APPENDIX

SUMMARY OF
COMMENTS
RECEIVED

Summary of Environmental Concerns and Comments | Highway 417 Bridge Replacements and Operational Improvements (GWP 4173-15-00)

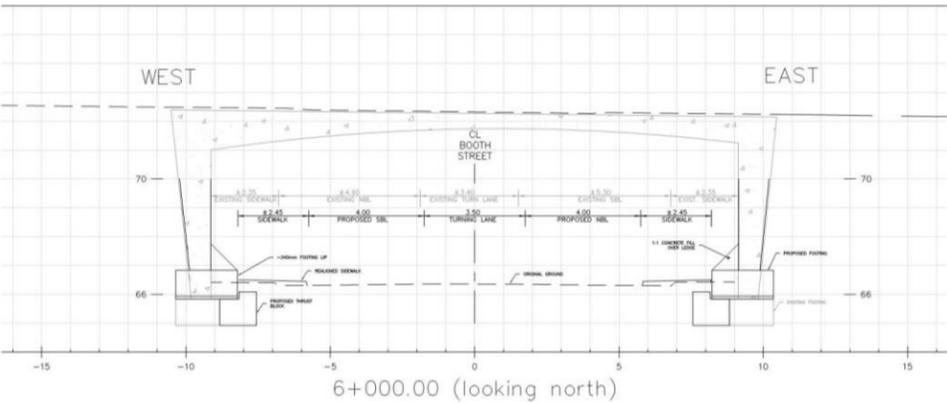
ID	Date / Form of Contact	Name / Agency	Comments Received	How it was addressed	Response Provided
			<p>maintenance not confirmed by City. Screen shot of wall below. Please advise of any expected impact.</p>  <ul style="list-style-type: none"> • Gateway feature SN019473 within road closure limits during rapid replacement for Preston close to Louisa St. This may require protection during construction activities, please advise of any anticipated impact, please protect as/if required. 	<p>construction operations. The Ministry of Transportation (MTO) has been in communication with the City regarding obtaining a Temporary Limited Interest during construction and is cognisant of the winter operations at this facility. The intent is to place restrictions within the Ministry's contract to ensure the construction occurs outside of the facility's winter operations schedule.</p> <p>Harmer Avenue Pedestrian Bridge All construction activities will be coordinated with the ongoing expansion of the Queensway between Maitland Avenue to Island Park Drive, as well as the new Harmer Avenue pedestrian bridge.</p> <p>Upstand / Retaining Wall on Bronson Avenue With the re-alignment of Chamberlain Avenue to opposite the existing E-N/S Bronson off-ramp, this small retaining wall will be removed, and the area regraded.</p> <p>Gateway Feature on Preston Street We can confirm that the gateway feature SN019473 will not be impacted during construction.</p> <p>We appreciate your interest in this study. Should you have any further questions or comments, please do not hesitate to contact me.</p>
